14370
 MADISON, WI
 PHEASANT BRANCH GREENWAY ENHANCEMENT
 CONTRACT NO.: 9517

ACCESS TRANSMISSION SERVICES, LLC
OUTSIDE PLANT CONSTRUCTION
TITLE: FIBER OPTIC CABLE ROUTE
PHEASANT BRANCH CABLE RELOCATE

PHEASANT BRANCH DRAINAGE PUBLIC IMPROVEMENT MAIN PROJECT NO. 57874-0001 MADISON, WI JOB NO. 40-4536-1-24

PROJECT NAME:
CONFLICT REVIEW - PHEASANT
BRANCH GREENWAY
ENHANCEMENT - CITY OF
MADISON - PRJ NO. 14370

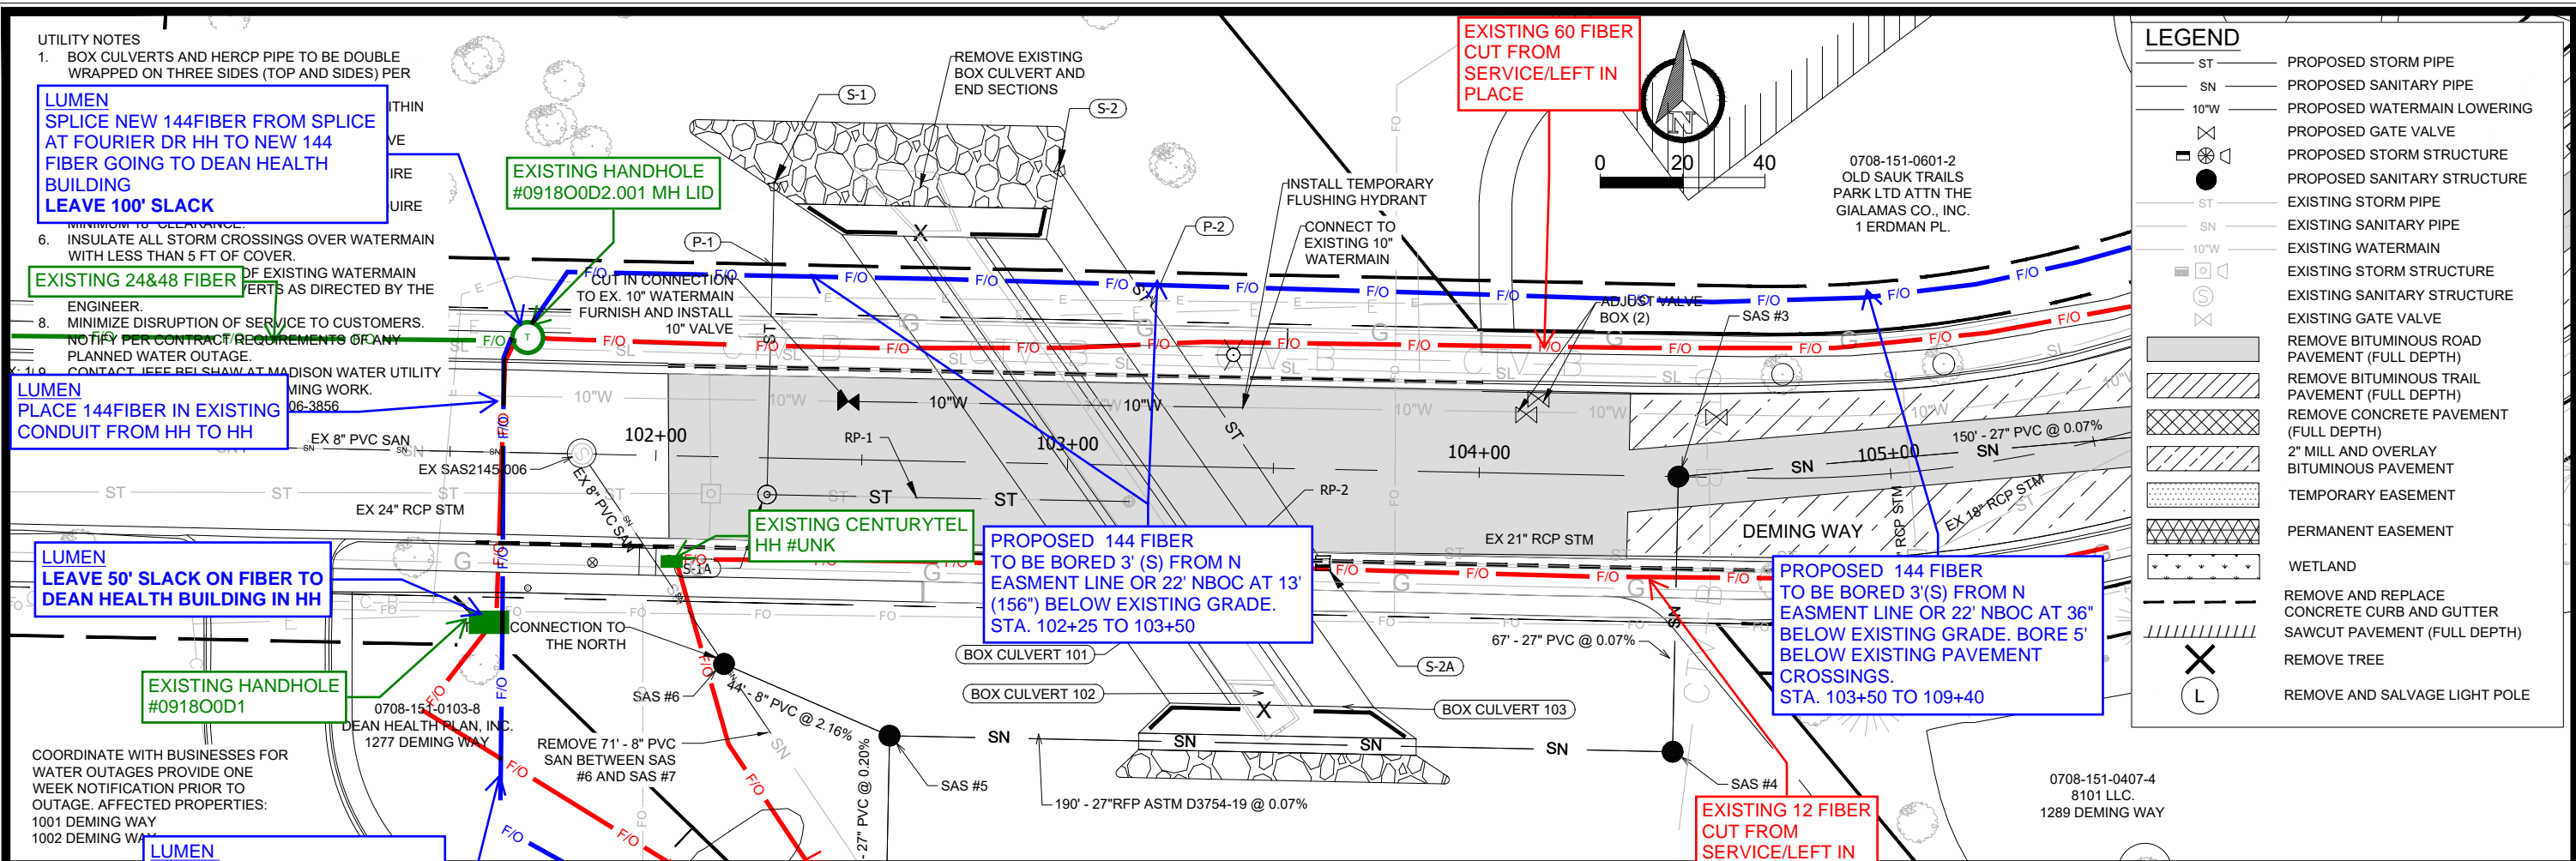
LUMEN
 PLACE 144FIBER IN EXISTING CONDUIT FROM HH TO HH

LUMEN
 LEAVE 50' SLACK ON FIBER TO DEAN HEALTH BUILDING IN HH

LUMEN
 PROPOSED 144 FIBER TO BE BORED AT 36" BELOW EXISTING GRADE. FOLLOW ALIGNMENT ON SHEET D6

UTILITY PLAN AND PROFILE - FOURIER DRIVE
PHEASANT BRANCH GREENWAY ENHANCEMENT

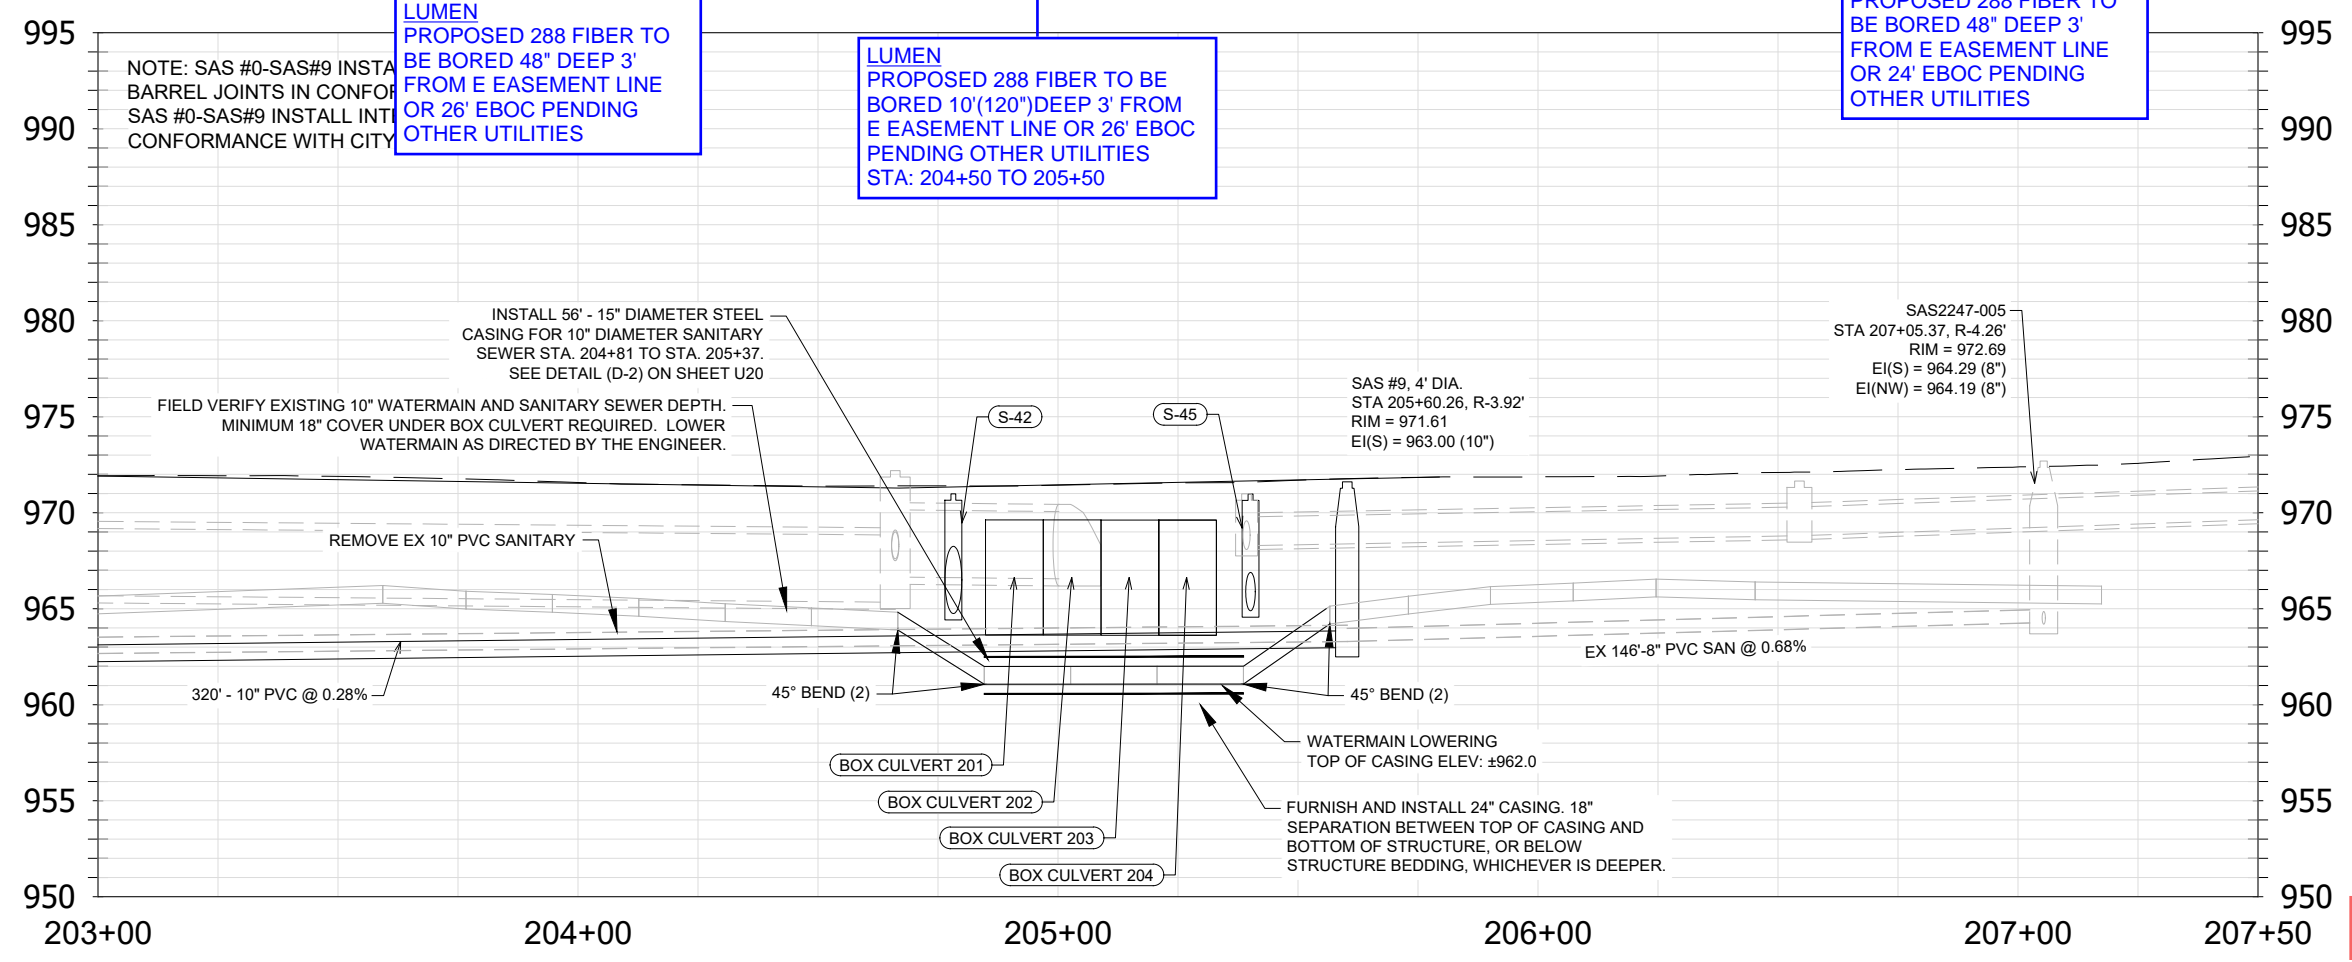
EXISTING 60&144 FIBER CUT FROM SERVICE/LEFT IN PLACE

LUMEN SPLICE POINT AT JOHN Q HAMMONS DR HH-0918004Y

LUMEN PROPOSED 288 FIBER TO BE BORED 48" DEEP 3' FROM E EASEMENT LINE OR 24' EBOC PENDING OTHER UTILITIES

LUMEN PROPOSED 288 FIBER TO BE BORED 48" DEEP 3' FROM E EASEMENT LINE OR 26' EBOC PENDING OTHER UTILITIES

PLAN SHEET 4

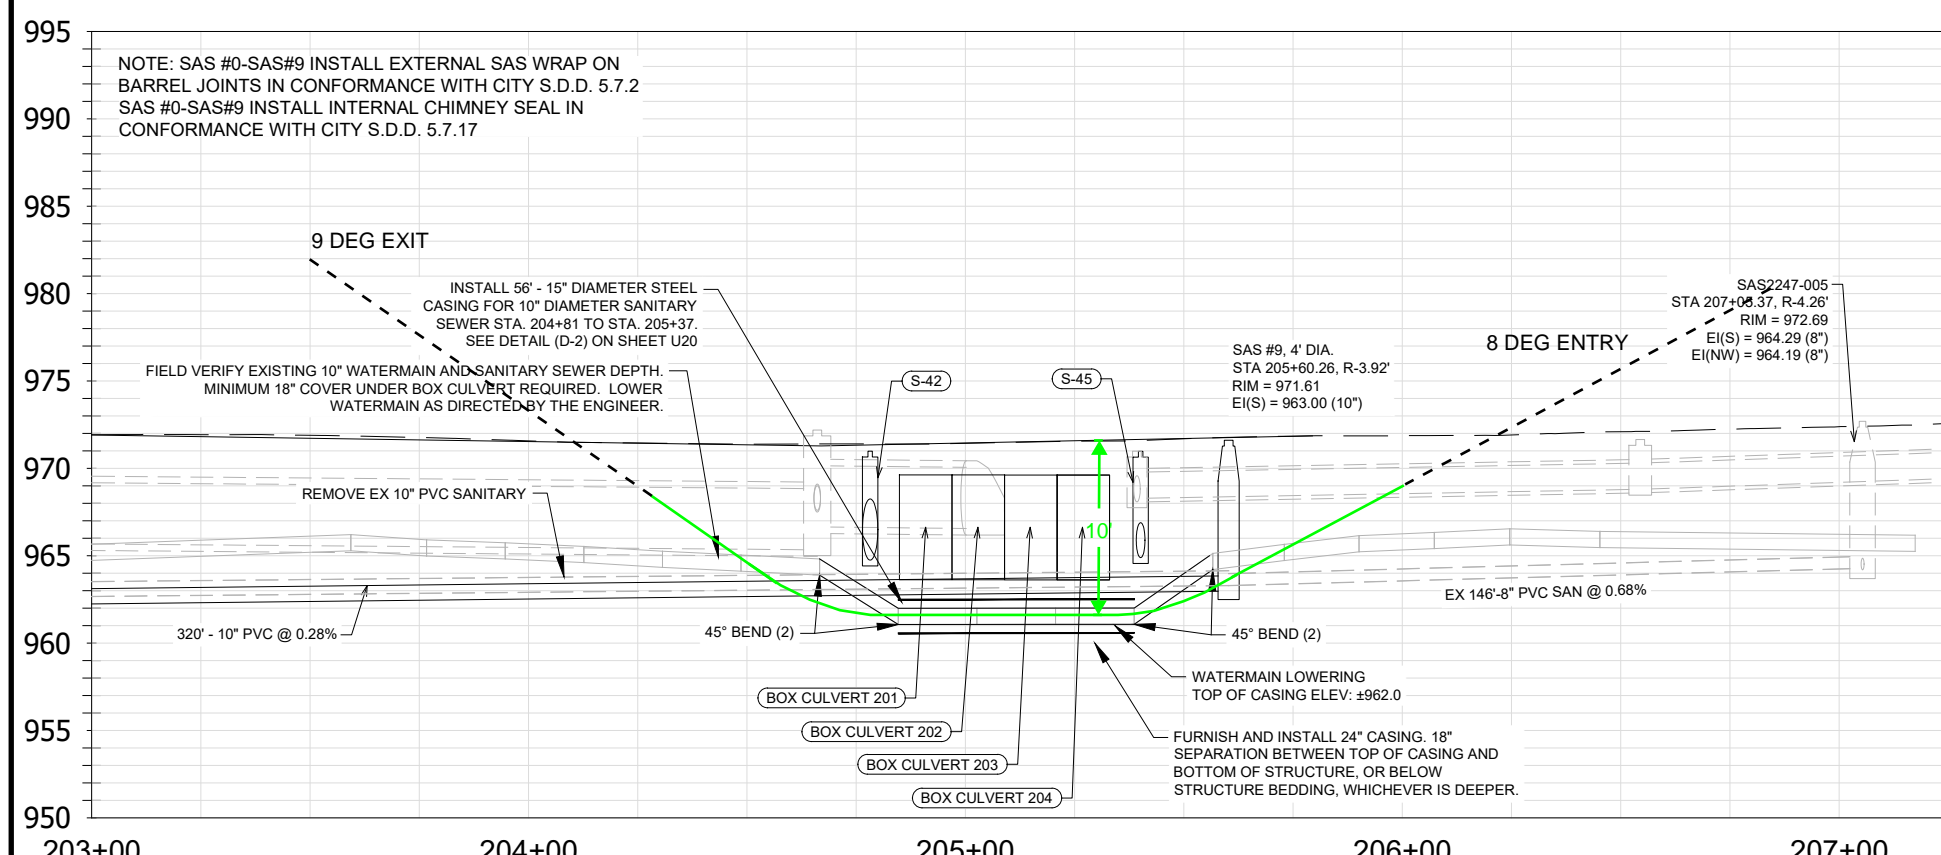
NOTES:
 - RELOCATE 2" LATERAL AND RECONNECT SERVICES THEN RETIRE EXISTING MAIN UNDER CULVERT PRIOR TO DRILLING IN NEW GAS MAIN UNDER CULVERT.
 - NEW MAIN TO FOLLOW RUNNING LINE OF MAIN TO BE RETIRED.

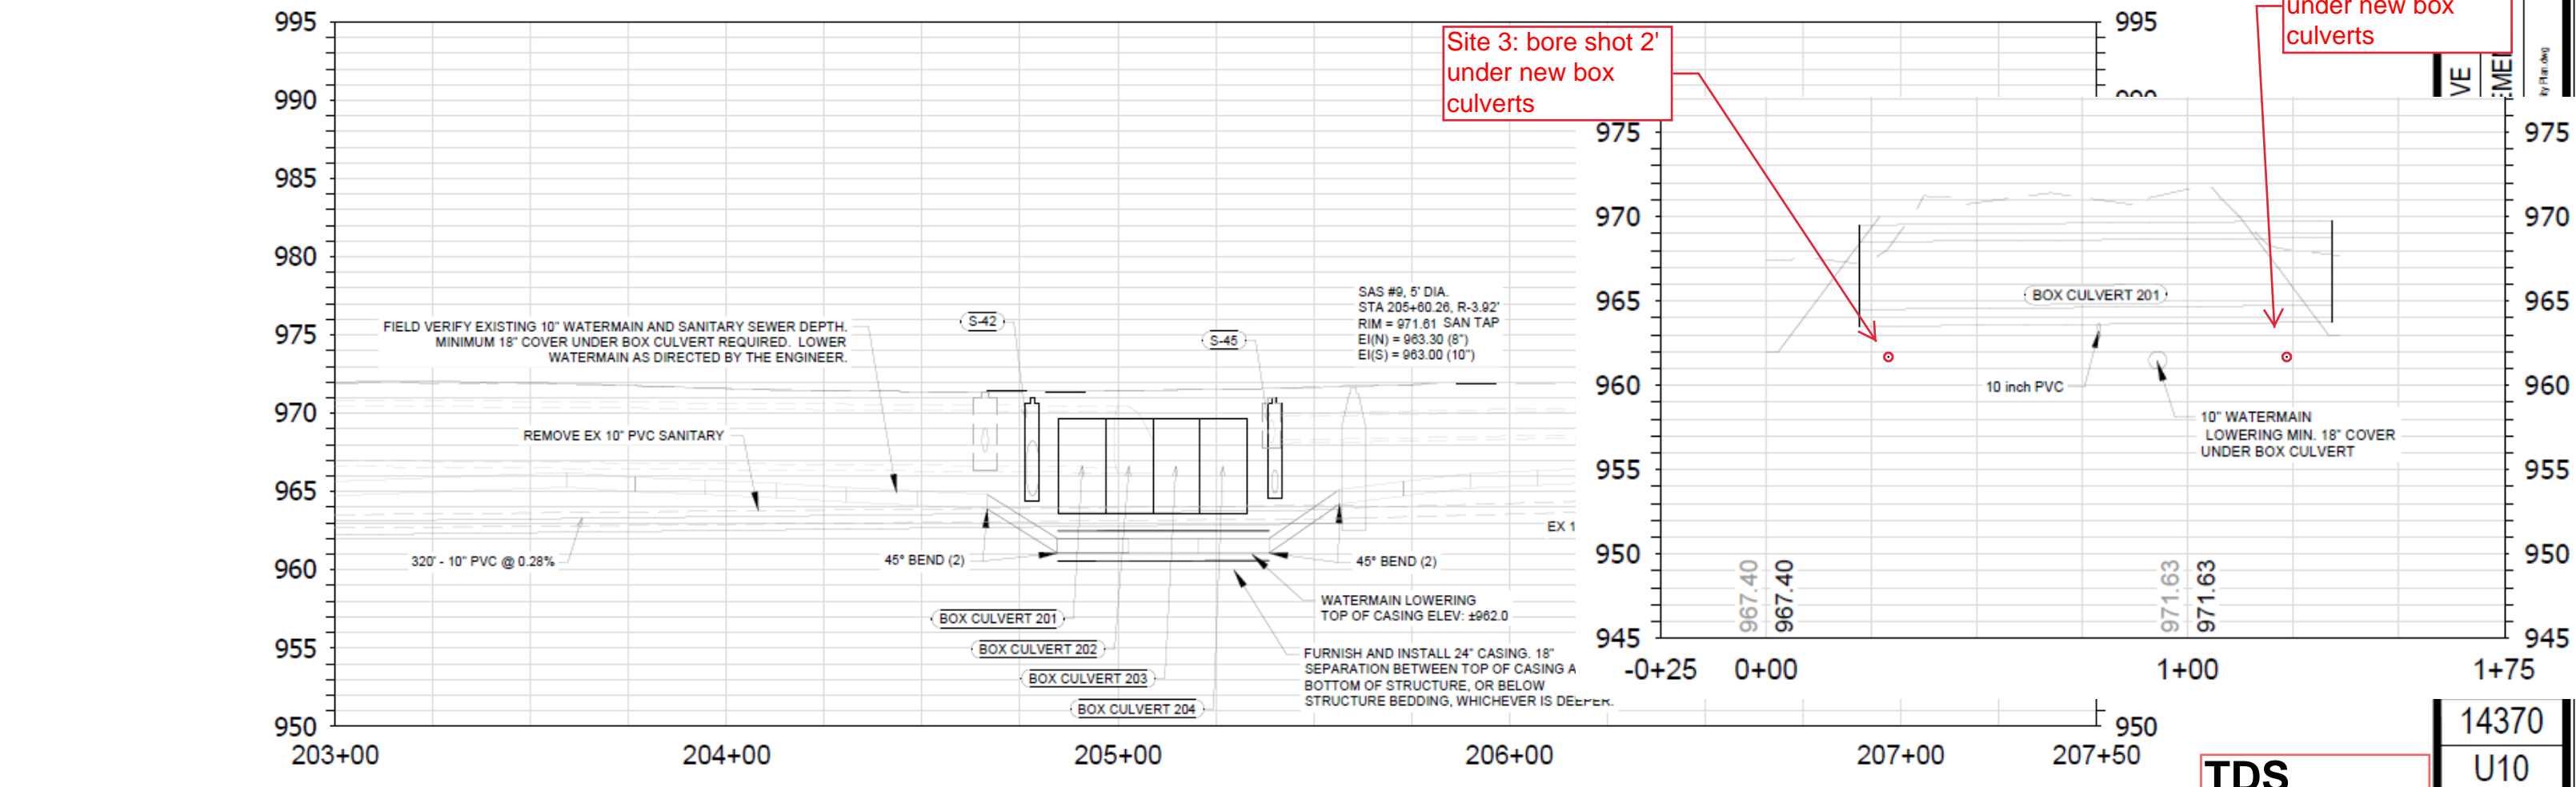
Install Metrocom handhole, telecom pedestal

Site 3: Installing 1 new pedestal, 3 handholes with splice cases; 260' boreshot with a 2" conduit (a 12F and 24F fiber), a 1.25" conduit (24F fiber) and a direct bury 100pr copper cable

UTILITY PLAN AND PROFILE - 1117 DEMING WAY STORM SEWER
PHEASANT BRANCH GREENWAY ENHANCEMENT

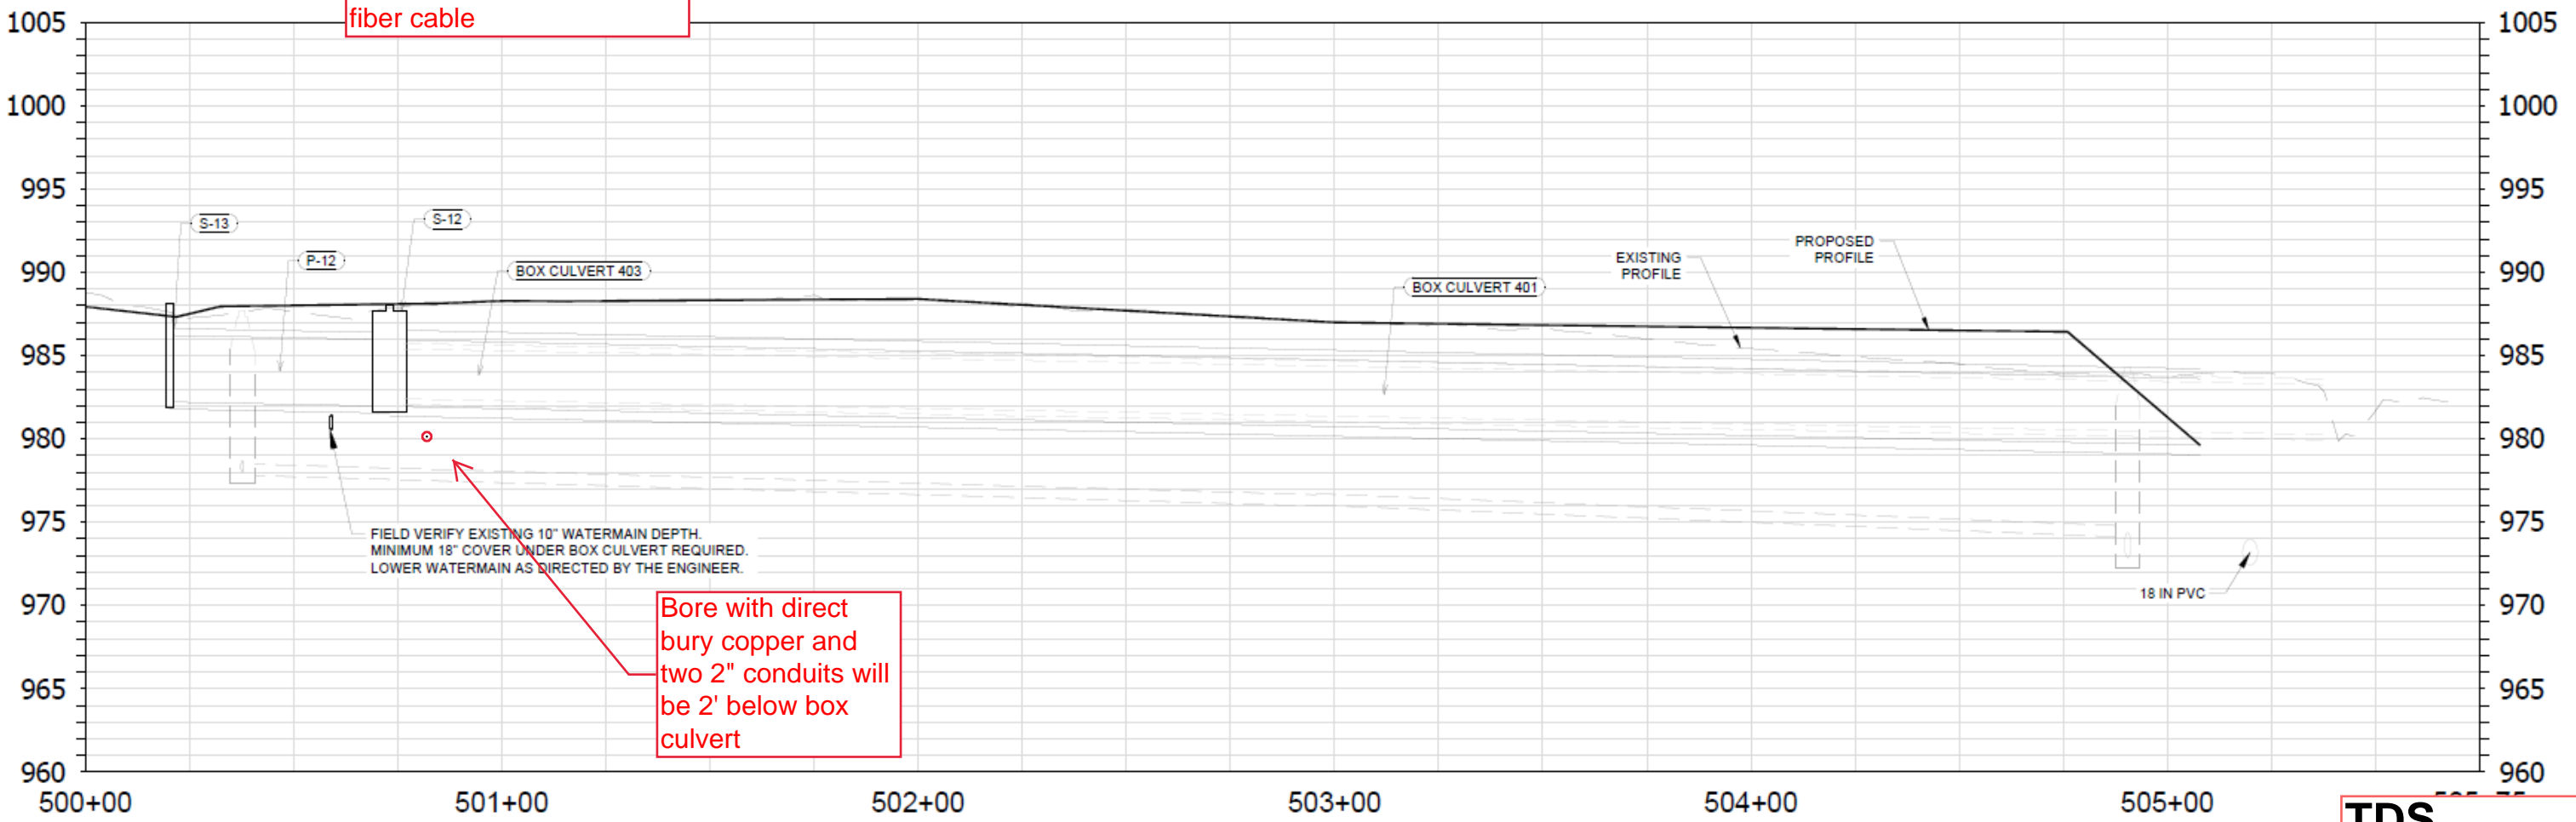
Site 6: Moving Pedestal and telecom handhole 20' south; placing 1 new Ped and two handholes north of construction zone. 145' bore; a 300pr copper cable direct buried, two 2\"/>

Bore with direct bury copper and two 2\"/>
